BROWNS FERRY NUCLEAR PLANT (BFN) - UNITS 1, 2, AND 3 LICENSE RENEWAL APPLICATION (LRA) - RESPONSE TO NRC REQUEST FOR ADDITIONAL INFORMATION (RAI) CONCERNING FOLLOW-UP TO RAIs 4.7.7-1 AND 4.7.7-2 (TAC NOS. MC1704, MC1705, AND MC1706)

TENNESSEE VALLEY AUTHORITY
BROWNS FERRY NUCLEAR PLANT (BFN)
UNITS 1, 2, AND 3
LICENSE RENEWAL APPLICATION (LRA)

RESPONSE TO NRC REQUEST FOR ADDITIONAL INFORMATION (RAI)
CONCERNING FOLLOW-UP TO RAIs 4.7.7-1 AND 4.7.7-2

Figure 2: Relationship of microstructural related radiation induced processes as a function of flux and temperature (from Scott, Reference 3). Note: 10^{-8} dpa/s is equivalent to $\sim 1 \times 10^{13}$ n/cm²/s.

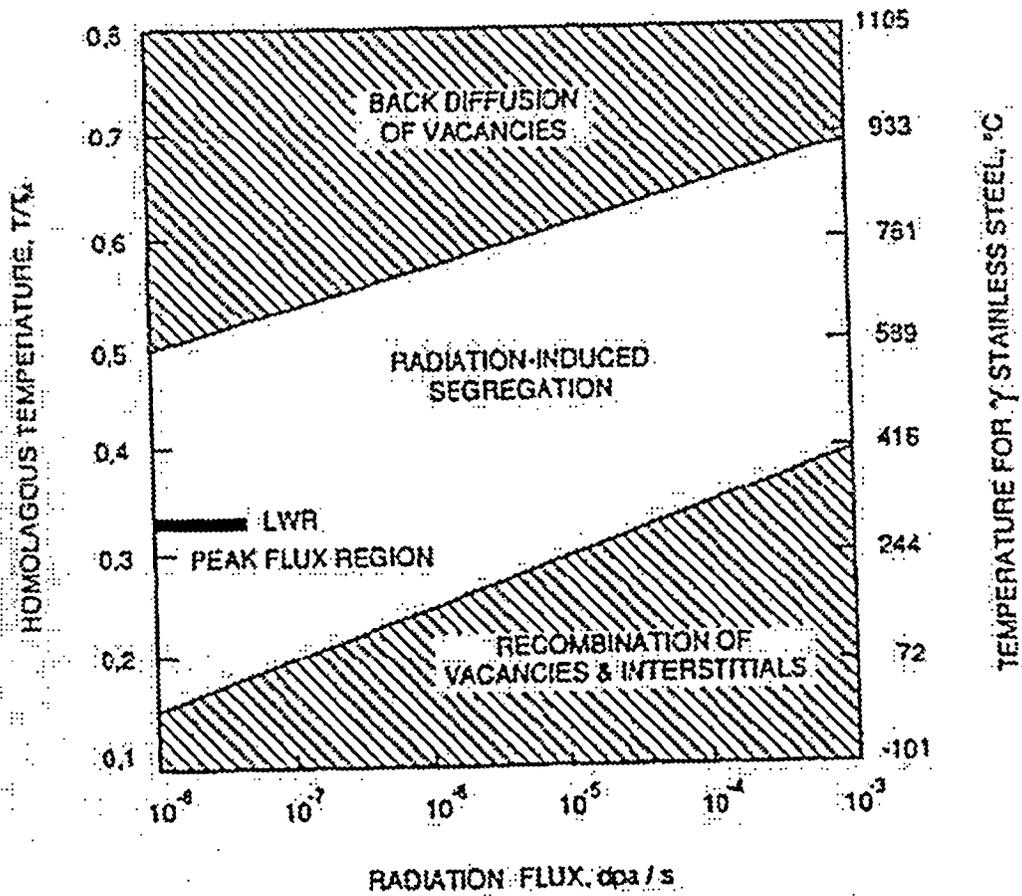
Figure 1 of the applicant's submittal dated June 29, 2005, compares the stress relaxation for the BFN core plate hold-down bolts, to the stress relaxation from the data derived from springs and bent beam stainless steel specimens. The staff request that the applicant provide information regarding the values of neutron flux and temperature at which the bent beam and spring test specimens were exposed, and compare them to the neutron flux and temperature values of the BFN's core plate hold-down bolts. If the neutron flux and temperature values for the BFN core plate hold-down bolts are different than that for the bent beam and spring test specimen data, evaluate the impact of these differences on the predicted stress relaxation values of the BFN core plate hold-down bolts.

Technical Support for the Use of the Current Stress Relaxation Data to Evaluate Core Plate Bolt Relaxation: The effect of radiation on microstructure is the driving force for stress relaxation with neutron fluence. The primary effect of radiation is to harden the material through the creation of vacancy and interstitial defects in the crystal lattice. These defects affect creep and segregation within the material which will increase the strength, produce stress

relaxation and lead to very narrow changes in the local composition at grain boundaries (Reference 2). The actual evolution of the microstructure is a complex process. Additionally, the data on materials under Light Water Reactor (LWR) conditions {i.e., temperature less than 350°C (662°F), fluences in the 0.5 to 5 dpa ($\sim 6 \times 10^{19}$ to $\sim 6.6 \times 10^{20}$ n/cm²) and attributable to a LWR neutron spectrum} is limited (Reference 3). Below this fluence level, degradation is just starting to occur. Following a short-term transient, the creep strain at constant load is very linear with fluence (which in turn is integrated flux over time) (Reference 4). Scott showed that the LWR operating flux/temperature region is one broadly associated with processes of limited microstructural dimension that in turn is associated with radiation-induced segregation (RIS) (Figure 2) (Reference 3). The continuity of these processes to lower flux levels is very much implied by Figure 2 for LWR material changes. Therefore, extrapolation of the higher flux data to the core plate region is fully justified and appropriate. Consistent with other microstructural processes, higher temperature and higher fluxes would be expected to produce bigger changes. The lower flux conditions would produce no additional effect on the relaxation behavior.
